Crimson Solar Project

Final Environmental Impact Report

State Clearinghouse No. 2018031027

May 2021

Figure W-1
Defenders/Council Alternative

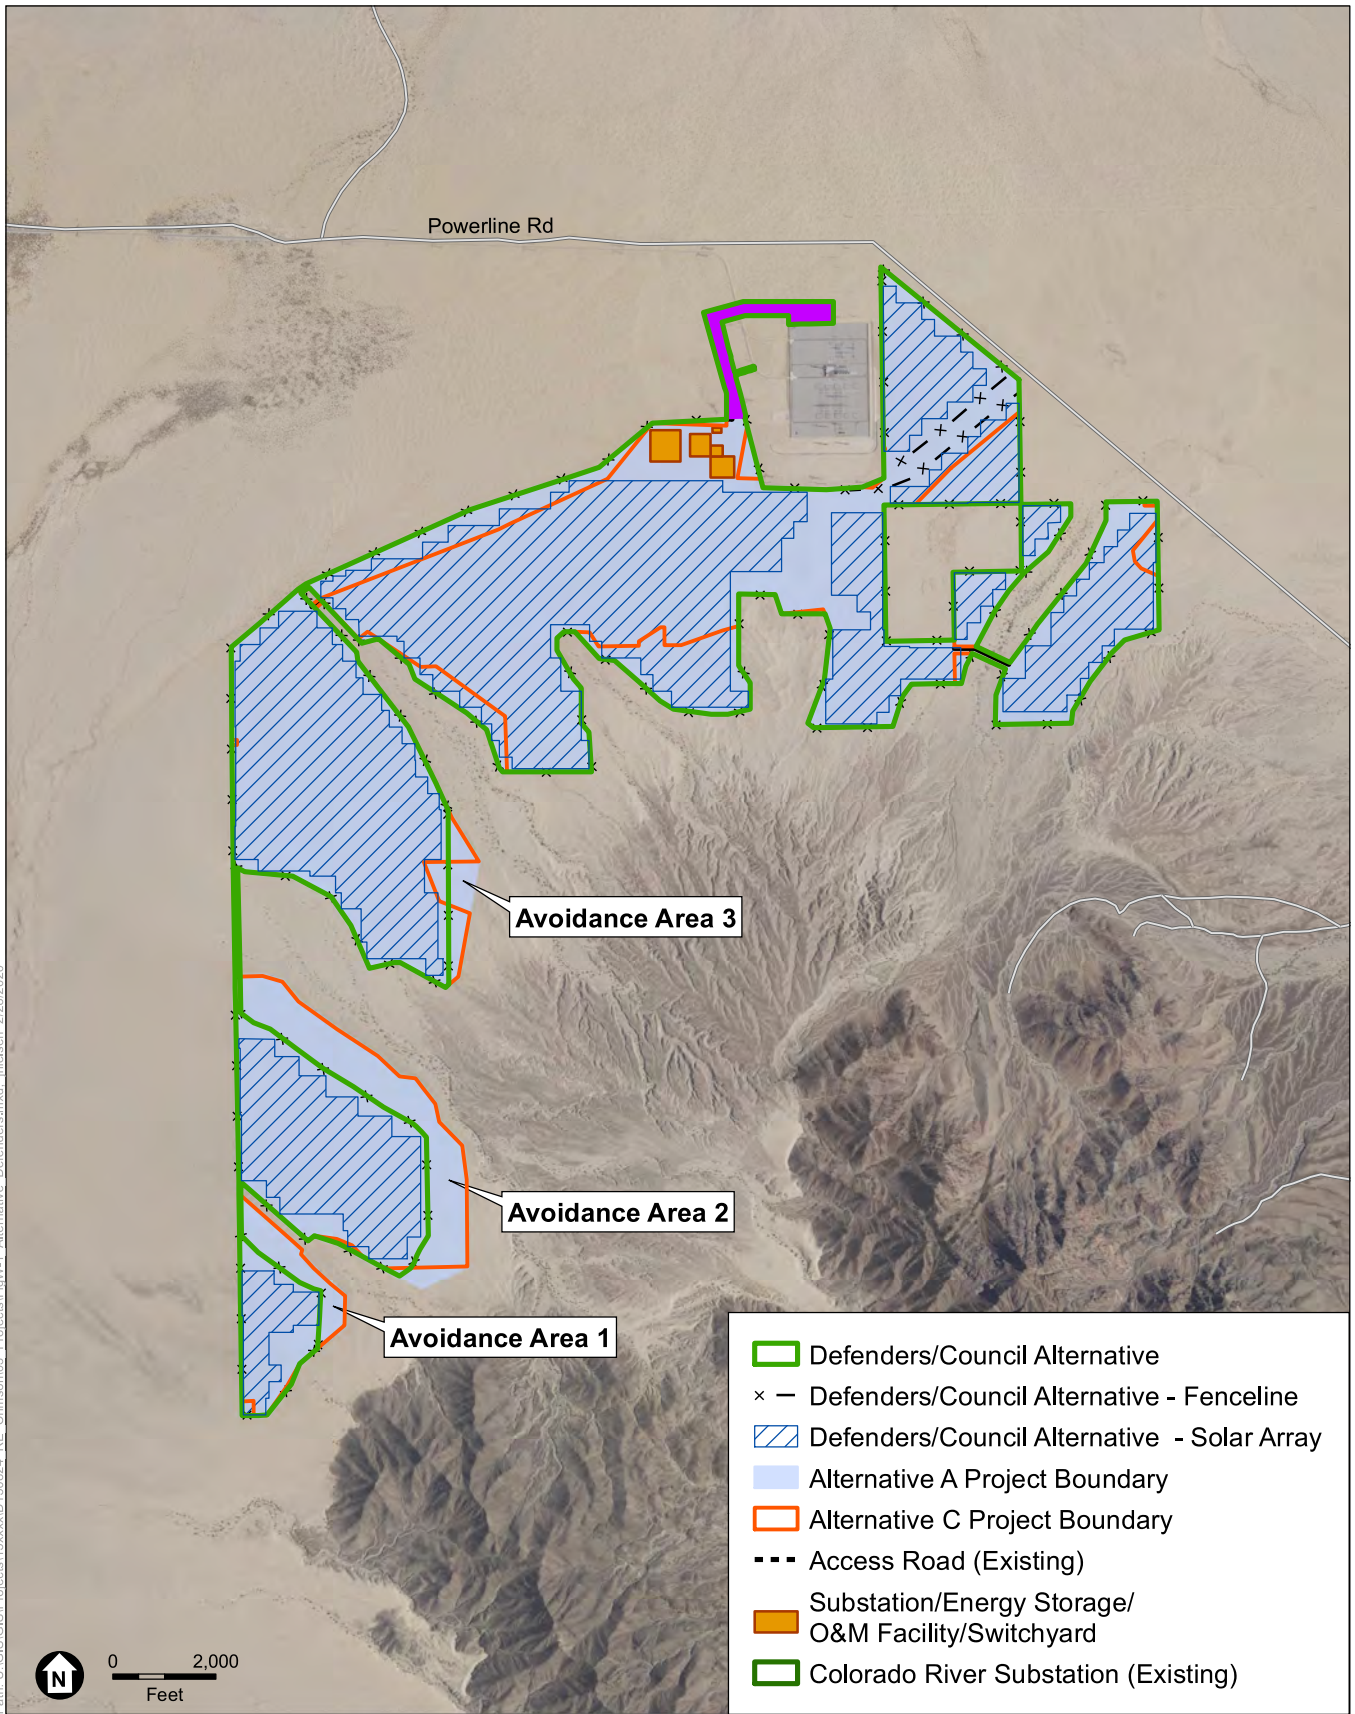
Comment: Defenders and the Council recommend an additional alternative be included and analyzed in the Final EIS/EIR for the Crimson Project that would avoid direct impacts to occupied habitat for the desert tortoise within two separate solar array fields in the southwestern portion of the Project. With slight modification, the project footprint and perimeter fence would avoid at least six desert tortoises encountered during protocol surveys, which are displayed on Figure 3.3-5, Appendix A of the DEIS/DEIR. This slight modification would exclude a relatively small amount of land from the project, not appreciably reduce electricity generation, and decrease direct impacts to the desert tortoise. A map of our recommended changes to the project footprint and perimeter fence location is included in map attached to this letter.

Figure W-1, presented following responses to this comment letter, provides a comparison of the boundaries of the proposed Project (Alternative A), the Reduced Acreage Alternative (Alternative C),¹ and the Defenders/Council Alternative. The available area for developing solar arrays within the Defenders/Council Alternative boundary would be 1,709 acres, compared with 1,859 acres under Alternative A and 1,684 acres under Alternative C (Draft EIS/EIR/PA Table 2-4, page 2-17). Therefore, the Lead Agencies acknowledge the comment’s assertion that this alternative would “not appreciably reduce electricity generation” and agree that this alternative likely is both technically and economically feasible. The Lead Agencies have already expressed a preference for the reduction in area under Alternative C to avoid key areas containing sensitive vegetation, sand dune habitat, and cultural resources; therefore, a more reasonable option for resource avoidance would be to combine the two boundaries to result in an even smaller developable area. This, too, likely would remain feasible.

The map on page 5 of the comment letter depicts the locations of tortoises and occupied burrows (along with other sign) identified during 2012 and 2016 focused surveys as well as 2017 incidental findings during other surveys (see Figures 7 through 10 in Appendix I.1 of the Final EIS and Proposed PA for original survey results). Based on this, Defenders and the Council identified three potential acreage reductions, labeled as “Avoidance Areas” on Figure W-1. As discussed in Section 3 of the Desert Tortoise Translocation Plan (DTTP, see Appendix I.12 of the Final EIS and Proposed PA), a study began in fall 2018 to number and track up to 50 desert tortoises in the Chuckwalla Valley for 18 months through spring 2020 using radio transmitters attached their shells. The purpose of this research was to help confirm existing densities in the Project boundary and adjacent habitat, provide movement data and activity areas, health status, inform the translocation process, and provide additional habitat data” and “may be used to determine the extent tortoises are using the Project site, increase certainty of the total number of tortoises that may be translocated, and assist in the determination of the most-appropriate recipient site.” Results of this study indicate that the relative size of tortoise home ranges varies within the study area (Ironwood 2020). Two of the transmitted tortoises’ home ranges include all or a portion Avoidance Area 1, and the relative tortoise density in avoidance area is low to moderate. Portions of seven transmitted tortoises’ home ranges intersect Avoidance Area 2, and the relative tortoise density is moderate to high within some of the avoidance area and low in much of it. Two of the transmitted tortoises’ home ranges include small portions of Avoidance Area 3, and the relative tortoise density in this avoidance area is low. Overall, nine individual tortoises were found to use a portion of one or more of the Defenders/Council Alternative Avoidance Areas, out of 37 tortoises from which data were collected. However, the portions of the Avoidance Areas used by six of these nine tortoises did not make up substantial portions of those tortoises’ home ranges. One other small area of the Project site was used by five tortoises. Most of the Project site showed no occupancy by transmitted desert tortoises, while tortoise density in the area between the Project site and the Mule Mountains was high. The tortoises that did use the Avoidance Areas also spent time in these higher-density areas outside the Project site.

Figure 1-3, Project Evolution, shows the original 2009 application area, followed by the 2016 and 2017 refinements. As demonstrated there and as explained in Section 1.1.2, Project Background, the footprint of the proposed Project has been reduced substantially as a result of discussions with stakeholders and agencies including the BLM and CDFW. Specifically, along the southeastern edge of the Project site, the proposed Project footprint has been pulled away from alluvial fans and washes at the base of the Mule Mountains to avoid high-quality desert tortoise habitat. Based on review of the transmitter data from 2018-2020, the Defenders/Council Alternative would not avoid or substantially lessen impacts on the desert tortoise population because few of the desert tortoises for which transmitter data is available use the Avoidance Areas as substantial portions of their home ranges. The USFWS Biological Opinion for the Project (2020) concluded that “Given the small number of desert tortoises potentially affected by the Project, we have no information to indicate that construction and O&M of the Project would appreciably reduce the desert tortoise population levels in the Colorado Desert Recovery Unit” and that “Few, if any, desert tortoises are likely to be injured and killed as a result of moving out of harm’s way or translocation.” The avoidance, minimization, and mitigation measures including the mitigation

Because the Project already has been refined, and mitigation measures imposed, to minimize impacts on desert tortoise, the Lead Agencies do not find that the Defenders/Council Alternative would substantially reduce significant impacts compared to the proposed Project. Therefore, this alternative has not been carried forward for detailed consideration in the Final EIS and Proposed PA.
